JLH Mark2 - An Improved Opto-Mechanical Approach to Open-Path *in situ* Water Vapor Measurement in the Upper Troposphere / Lower Stratosphere

We would like to thank reviewer RC1, Prof. Darin Toohey, for his excellent and detailed comments on our manuscript. Below are our responses to each comment in order.

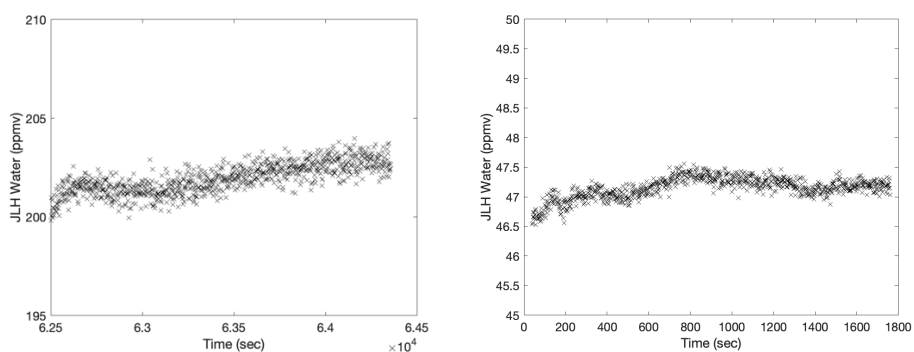
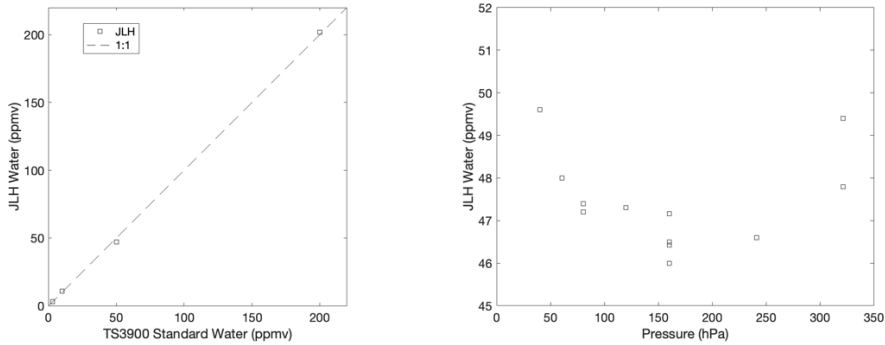
7. Line 577-588: The AIDA chamber demonstrations are an important "necessary" condition for the water vapor sensors that participated, meaning that one would expect the instruments to agree to within their stated uncertainties. In this case, you report "within 10% over a wide range of temperatures" which seems to be considerably larger than a back-of-envelope estimate of errors you note of 1% to 2% of various components of your careful analysis when added in quadrature. Because the JLH family of instruments are so critical to our understanding of stratospheric water, representing the only near-continuous record of in situ observations from aircraft spanning over three decades, it seems to me this paper is an excellent opportunity to "plant the flag" and make definitive statements about your best estimate for true uncertainty in the measurements without worrying about other methods which are much more difficult to "prove" from first principles. Although not required for this paper to be publishable, I think you should expand on this section, if only a little, – perhaps ½ to 1 page – to provide your best "sense" of what the true uncertainties in the water vapor mixing ratios are when the instrument is working properly. Hopefully at some point you will have a more rigorous analysis of

uncertainties, as this would be a very useful addition to the literature and historical record for JLH. Until then, would it be possible to make a summary statement about the largest sources of error in the JLH measurements and what they add up to in terms of accuracy over a typical range of pressures and temperatures for your flights?

In Section 2.3.2 (see below), we will provide a summary statement about the largest sources of error in the JLH measurements and what they add up to in terms of accuracy over a typical range of pressures and temperatures for recent flights. We will also revise Section 2.3.2 (at line 326) to show recent calibration results:

“Below, we describe a recent example of JLH laboratory calibration. Fig. 4a and 4b show time series of JLH measurements within the lab calibration chamber as 200 ppmv and 50 ppmv, respectively, are flowed through the chamber.

Fig. 4c demonstrates the linearity of JLH response versus reference gas standard from the TS3900 from 3 ppmv to 200 ppmv. This is also shown in Table 3 along with the difference in percent and ppmv. Generally, results are within 9% but there is a pressure dependence as shown in Fig. 4d. This pressure dependence has been documented in our previous laboratory calibrations. At higher and lower pressures, the response changes systematically.

Figure 4. (c) Left plot demonstrates that the relation of JLH water measurement to TS3900 water source is close to linear. A 1:1 line (dashed line) is also shown. (d) Right plot is JLH water measurement inside lab calibration chamber at different total pressures while the TS3900 provides a constant source of 50 ppmv water vapor at room temperature.

The best estimate of JLH total error for NASA SEAC⁴RS and more recent FTB flights is 12%, adding in quadrature the following terms. The largest error source is 9% in water measurement due to mismatch of the actual lineshape and the predicted lineshape as manifested as pressure-dependence (Fig. 4d). We estimate 5% uncertainty in water

measurement from uncertainty in the temperature dependence of the actual lineshape and 6% from scaling to laboratory calibrations (Fig. 4c and Table 3). There is 1% error in water measurement due to uncertainty in the in-flight temperature and pressure measurements. Finally, only 0.1% uncertainty in water measurement is due to uncertainty in the pathlength, and a fraction of a percent from other error sources such as wavelength, laser spectral purity, light scattering, et cetera.
